**CERTIFICATE OF APPROPRIATENESS**

**RE: Application Number 21-7157; 1466 Seminole; Indian Village Historic District**

Re: **1466 Seminole Street- Single Family Residence**  
Indian Village Historic District

Re: **1466 Seminole Street- Single Family Residence**  
Indian Village Historic District

6- Front Walk Existing, detail

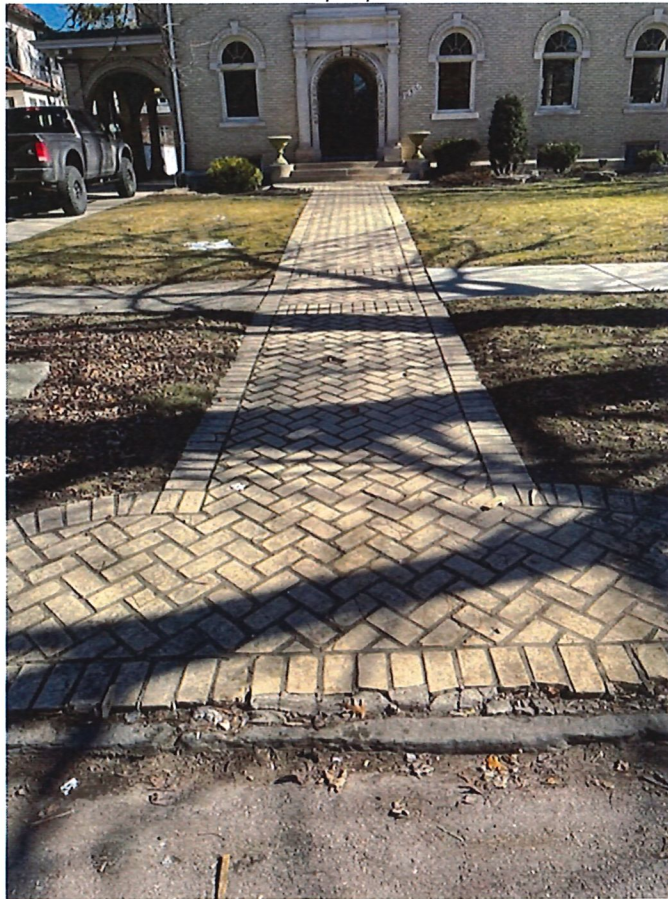
- *Would the owner be open to a combination of having the original brick as an edge to the proposed walkway?*

No. Photos# 6-8 show the wear and tear of the brick pavers long term. The pavers provide a hazardous slick surface when wet that the applicant desires to remedy. This walkway currently in place is not original to the home. As installed by prior homeowner, a violation was issued in 2000 with no Commission review.

SHEET DESCRIPTION:  
ARCHITECTURAL SITE PLAN-  
EXISTING CONDITIONS

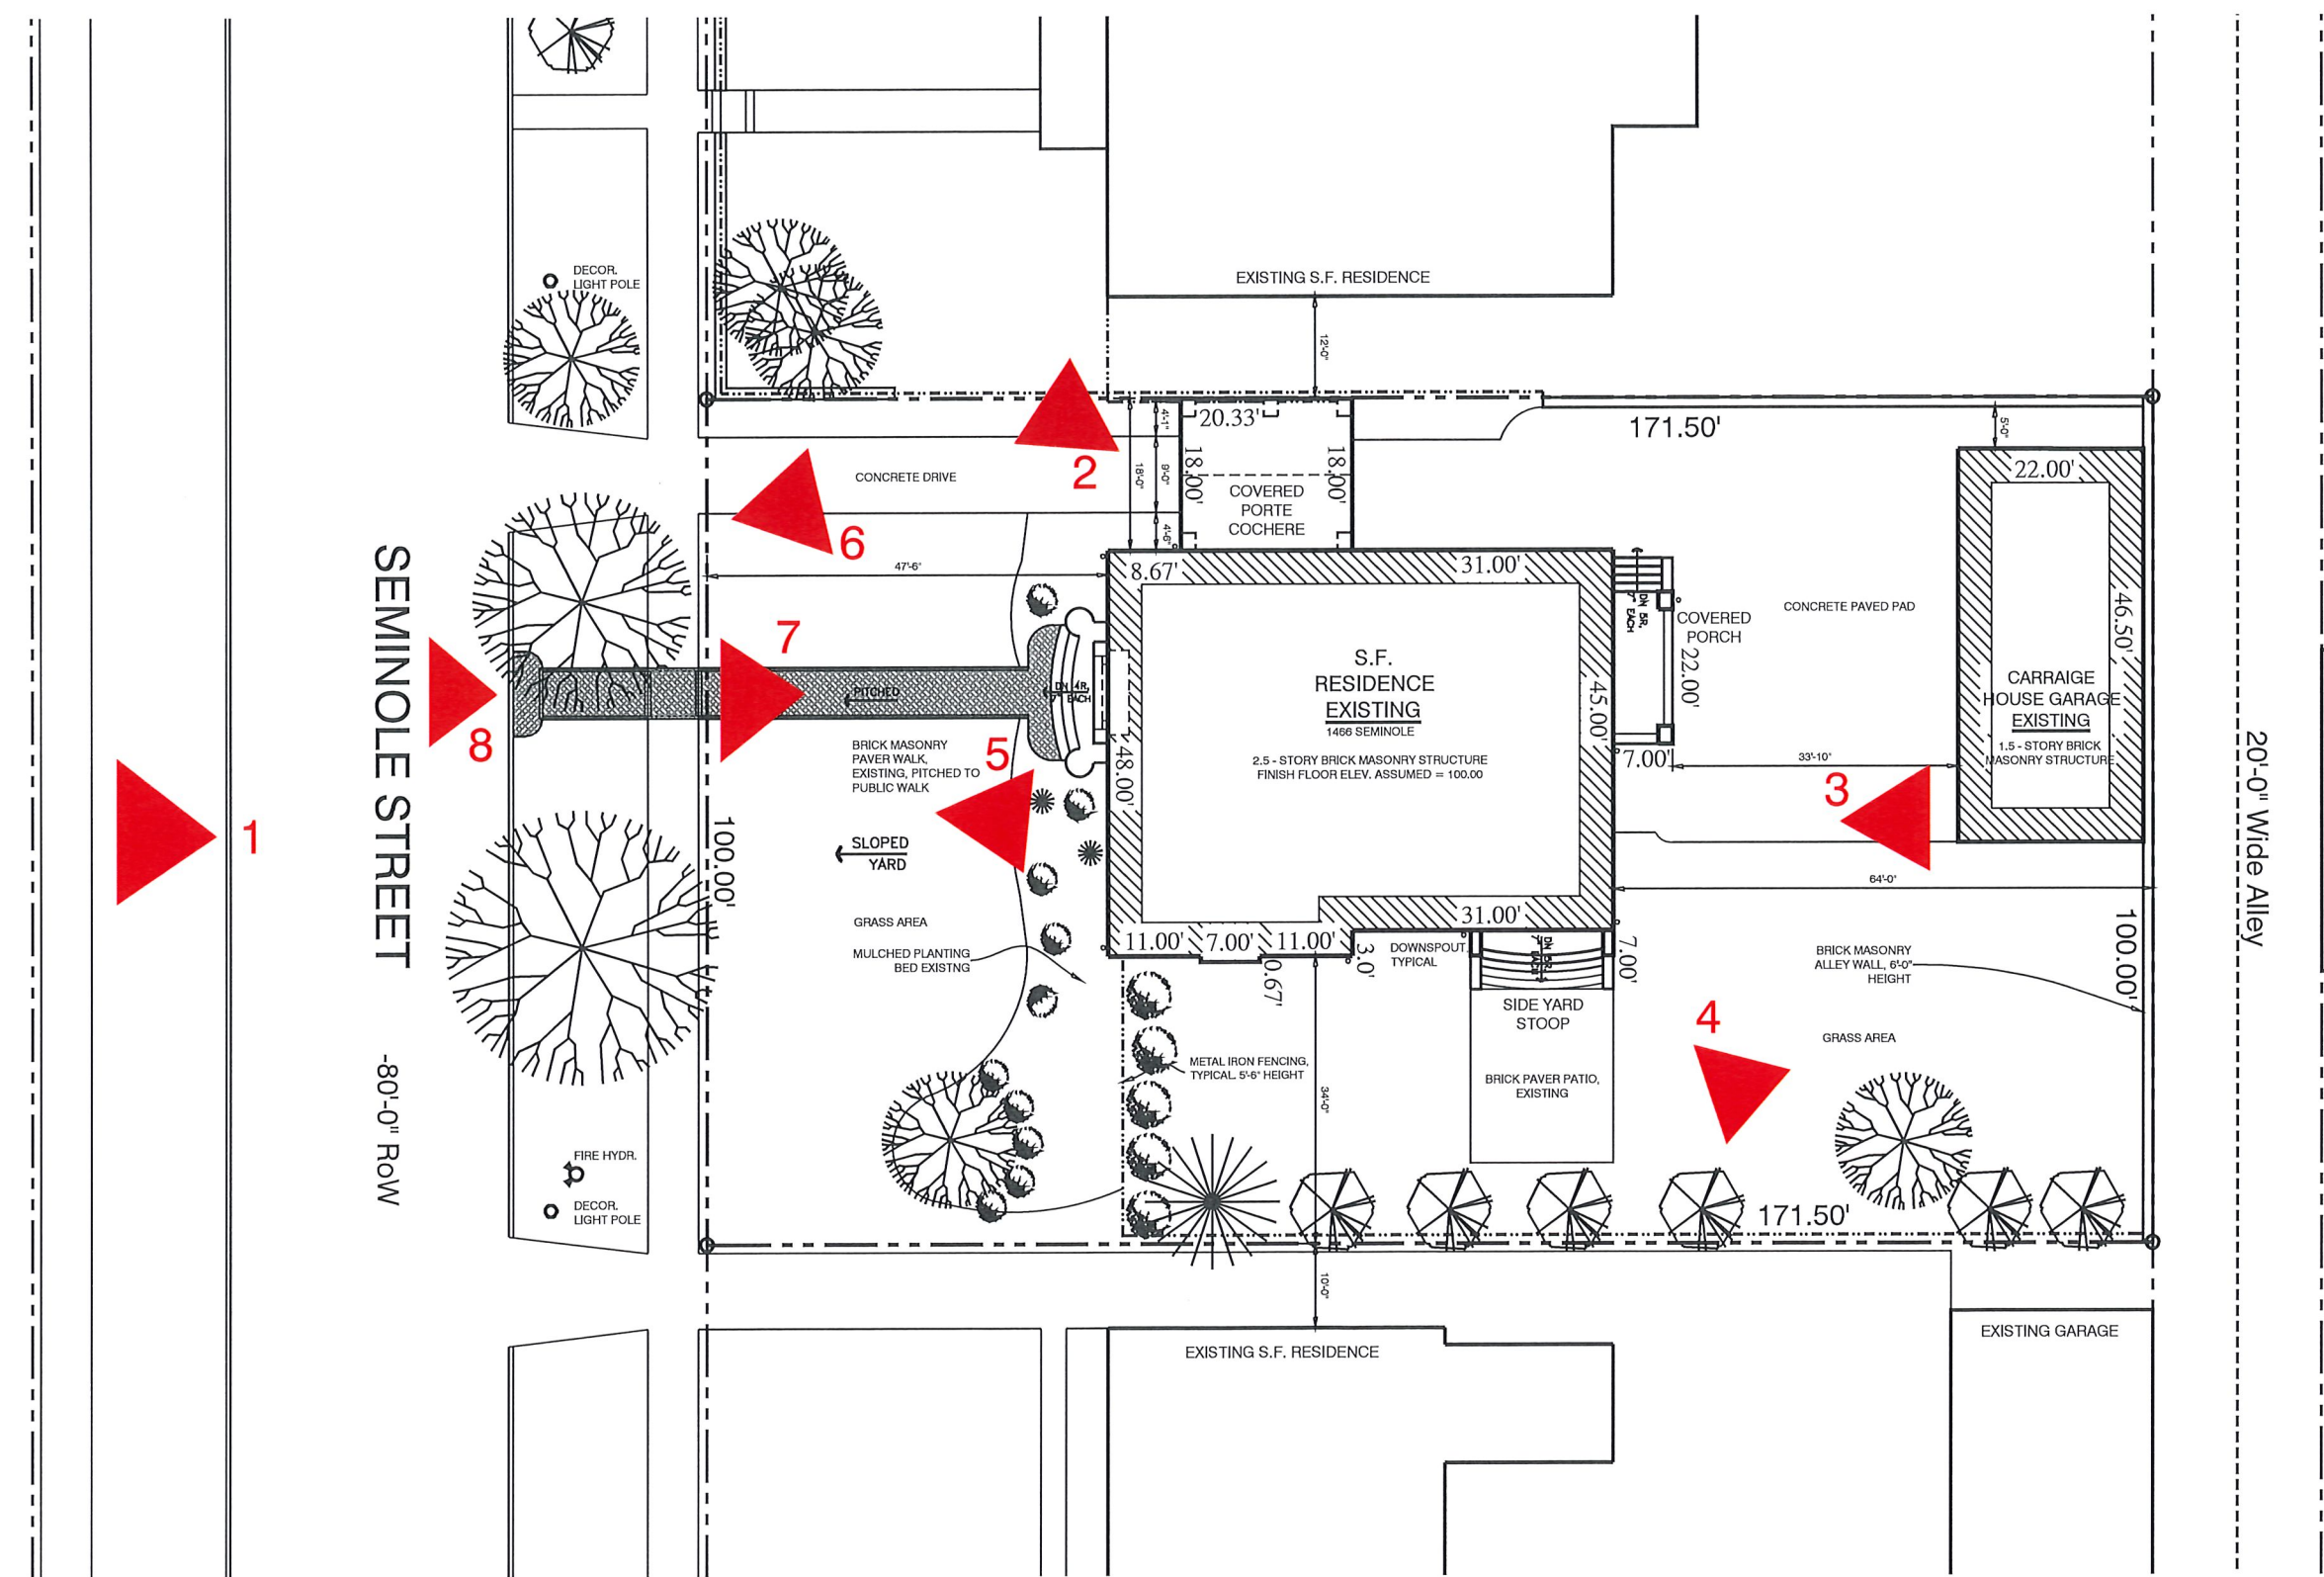
- *The proposed site plan (A-1) shows hatching on the public sidewalk. Are you proposing to change/alter the existing public walkway? If so, please describe what is being changed.*

Yes. Drawing A-01, with Photos #1 and 8 show the front approach current (brick pavers) intersecting the public sidewalk. This 6'-0" x 6'-0" portion will be removed and replaced with **a new concrete slab** to match elevation/material of that adjacent North/South, compliant with City specifications.

ENLARGED AREA OF WORK

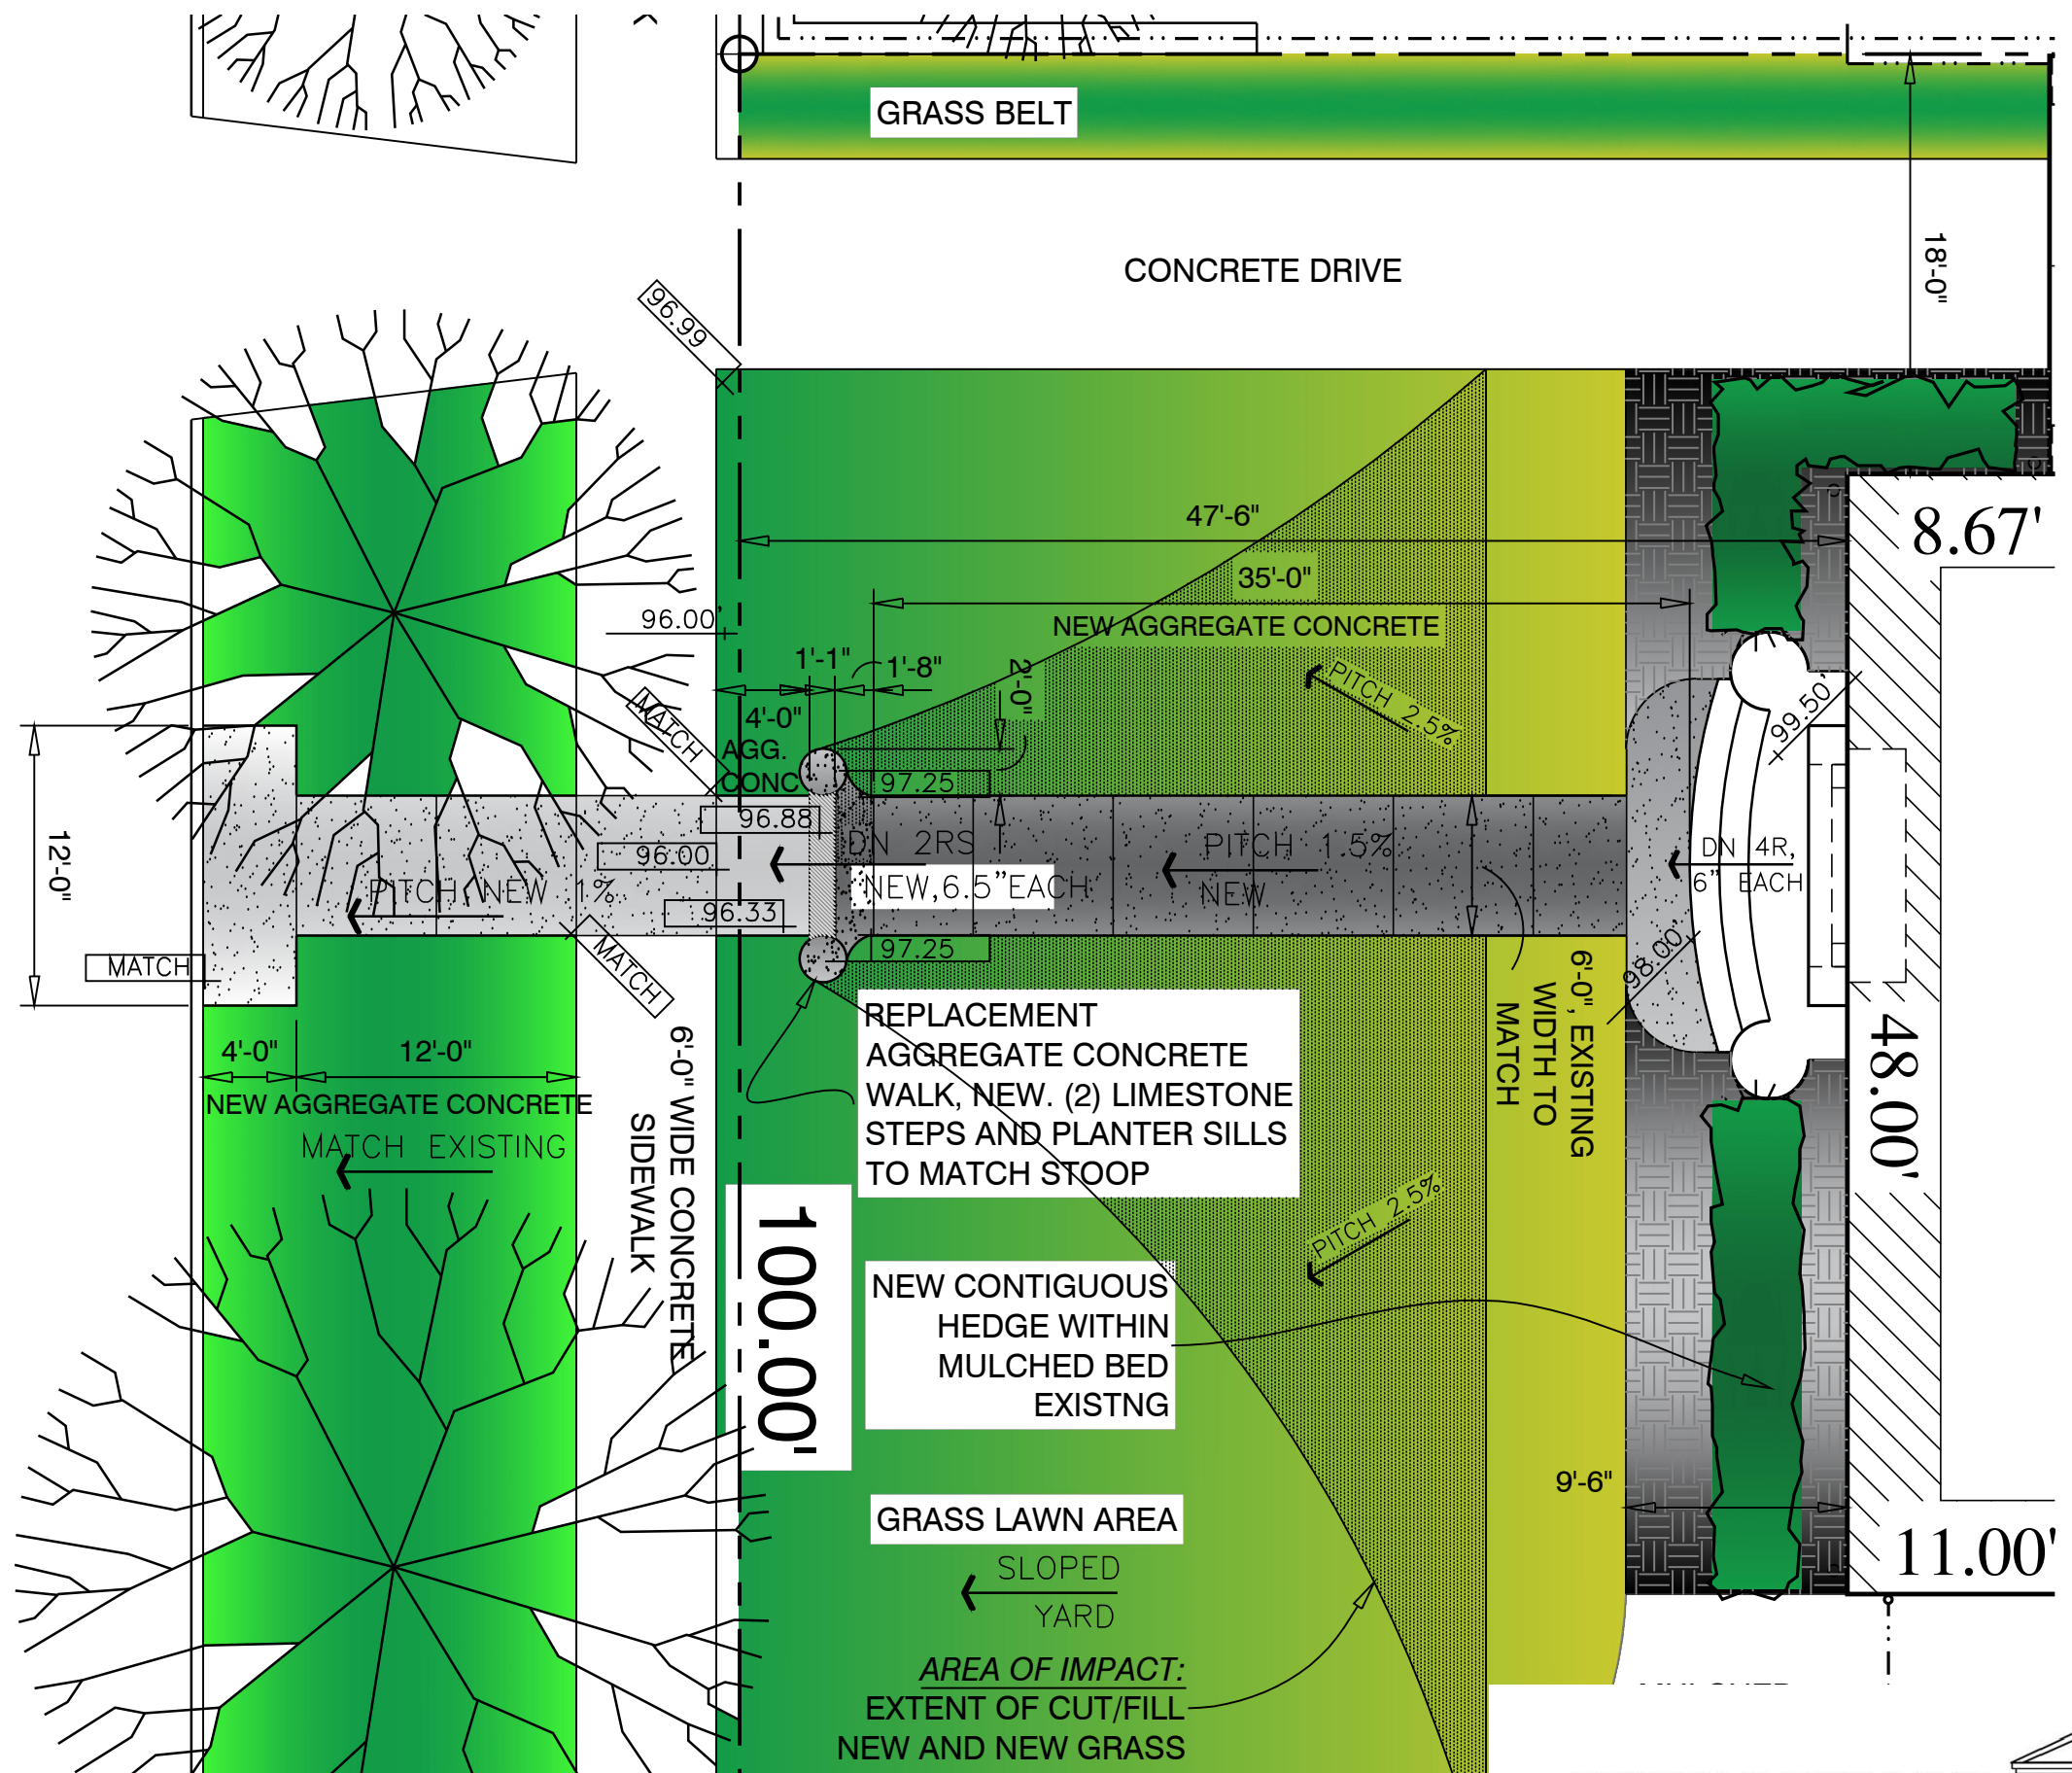
- *Please provide spot elevations and pitch (% slope) of the walkway from the existing steps to the proposed steps, bottom of proposed steps to the curb. Top and bottom of slopes is all that we need to show how grade is changing from existing to new grades.*

Enlarged Area Work plan is updated to provide for design intent clarity. Applicant/owner verified civil grades necessary for existing yard slope and proposed new work. *Existing is 24" drop from the face of the residence to the City public walkway.*

Please see the Enlarged Area of Work Plan revised.
